**To:** Hawkins, Andy[hawkins.andy@epa.gov]; Keas, Ashley[Ashley.Keas@dnr.mo.gov]  
**Cc:** Wilbur, Emily[emily.wilbur@dnr.mo.gov]; Avey, Lance[Avey.Lance@epa.gov]; Algae-Eakin, Amy[Algae-Eakin.Amy@epa.gov]; Gonzalez, Larry[gonzalez.larry@epa.gov]; Jay, Michael[Jay.Michael@epa.gov]  
**From:** Vit, Wendy  
**Sent:** Tue 8/11/2015 2:20:38 PM  
**Subject:** RE: Interactive Source Question Follow Up

**From:** Keas, Ashley [<mailto:Ashley.Keas@dnr.mo.gov>]  
**Sent:** Monday, August 10, 2015 1:49 PM  
**To:** Hawkins, Andy  
**Subject:** Interactive Source Question Follow Up

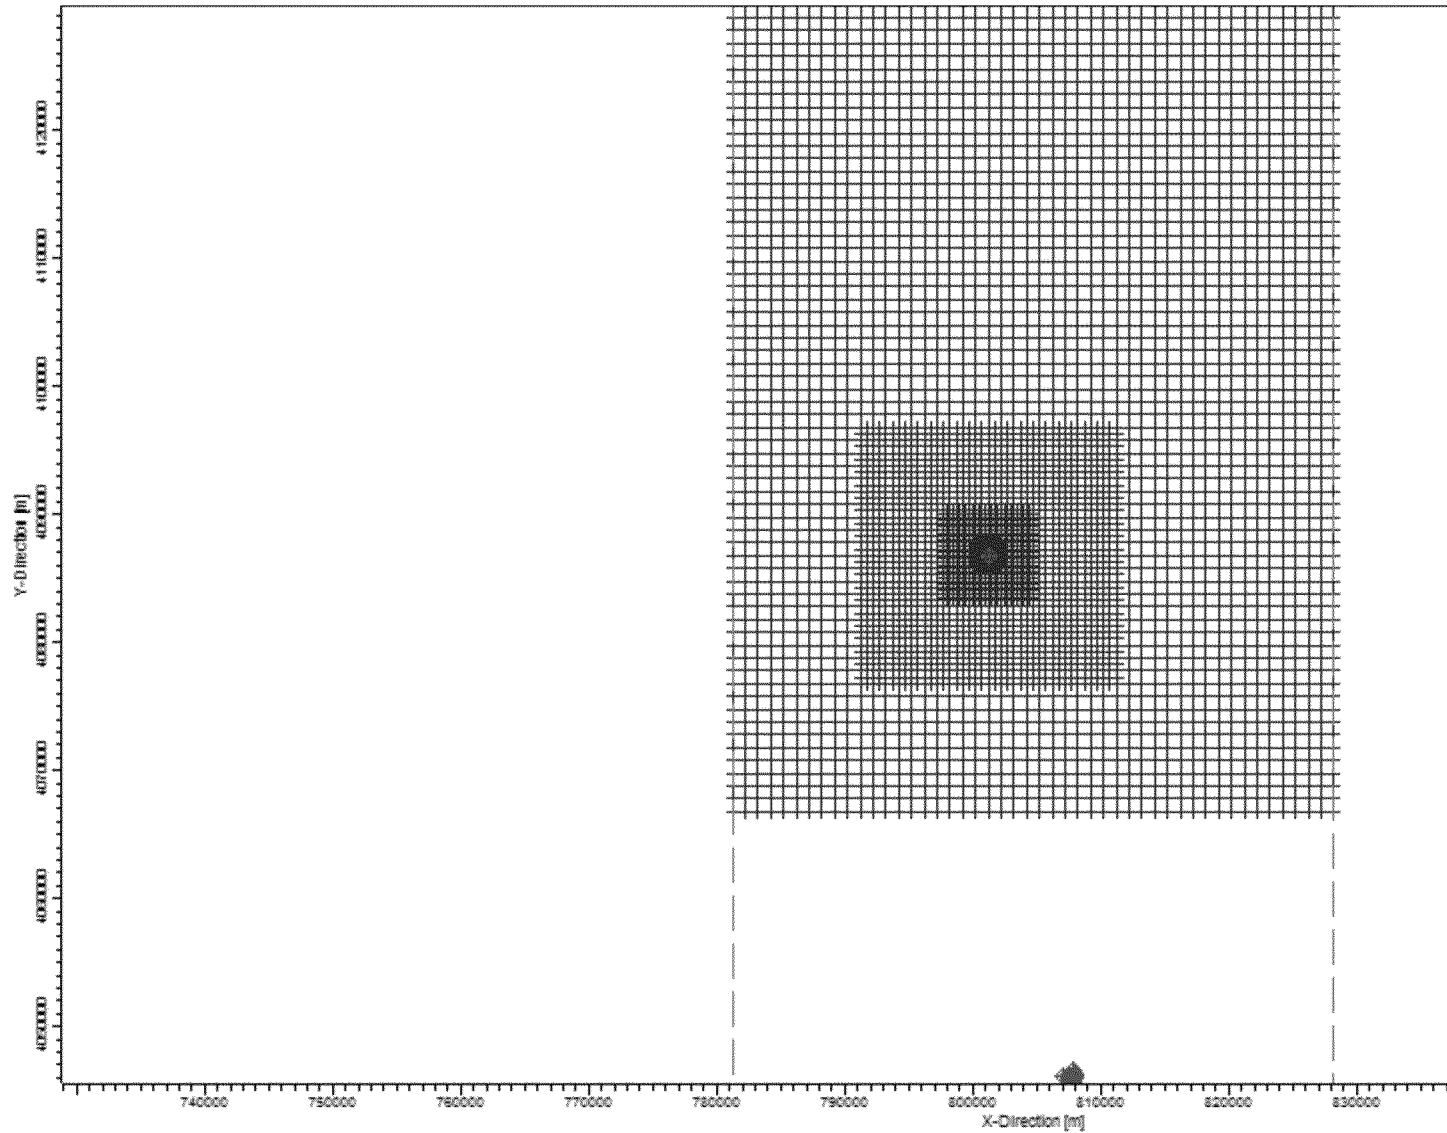
Here are the sources in arcmap for the input file I have, so receptors look fine, but the interactive sources are all bunched to the south (all new madrid I guess). So this means that Buzzi Unicem is not modeled explicitly? It's very close to the proposed attainment area to the north. In the SIP document it says Buzzi is modeled but it does not show up when I map it in the location I expect it at anyway. So please check Buzzi... could be my input file or maybe my import does not work correctly. So the new madrid locations may all be correct, maybe Buzzi is just not in the input?

Can you please verify the Sikeston interactive source locations in the AERMOD input file you

sent... the locations of the interactive sources look questionable when I import them using the supplied input file for this CD source.

You are correct. We inadvertently sent you an outdated input file since we had multiple people doing the last minute runs. I will have someone FTP the correct files to you tomorrow.

Sorry about that. Thanks for bringing it to our attention. We are correcting the modeling file Appendix too.
